Advanced LIGO+(A+)/Advanced Virgo+(AdV+) Coating Report

October 2021

The panel listed at the end of this report were invited by the A+ and AdV+ leadership to evaluate proposals from the major low-coating-thermal-noise (CTN) Coating R&D centers, describing the properties and maturity of the promising candidates that have emerged from ongoing R&D towards a new practical coating material for use in the O5 observing run of A+ and AdV+.

Figure 2. Predicted Brownian noise for ITM and ETM stacks made of alternating layers of titania-germania and silica.

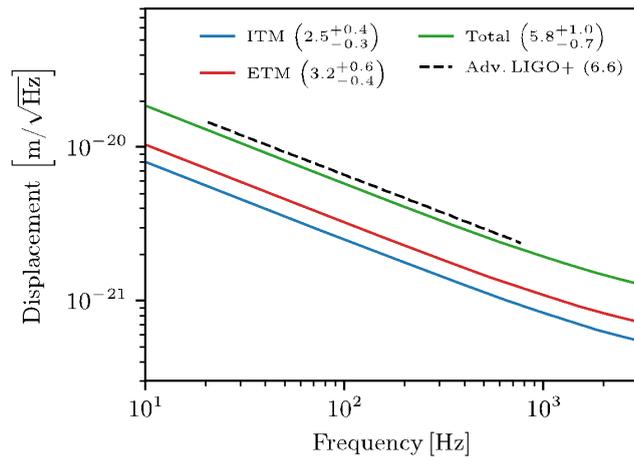
We computed the coating Brownian noise based on this design, the measurements from the single layer reported above, and the model from [3]. Figure 2 shows that the predicted Brownian noise, extrapolated down to 100 Hz, meets the Advanced LIGO+ requirements.

Additionally, the mechanical loss angles have been measured at 1 kHz and above, so the Brownian noise prediction is an extrapolation from the frequency dependence of the loss angles. A direct measurement of thermal noise on a defect-free annealed sample has not been possible yet.

- The lower refractive index means that all coatings will be thicker and will require longer deposition times, increasing the risk that something could go wrong during a coating run.
- The issue of blistering in high reflection stacks when annealing is still unsolved.
- The thermal noise prediction (factor of 2 reduction) has not been demonstrated yet in a HR mirror.
- Absorption at the 0.5 ppm level has not yet been verified.
- The coatings need to be annealed at higher than usual temperature (though not approaching any annealing limitations, so this is a minor point).
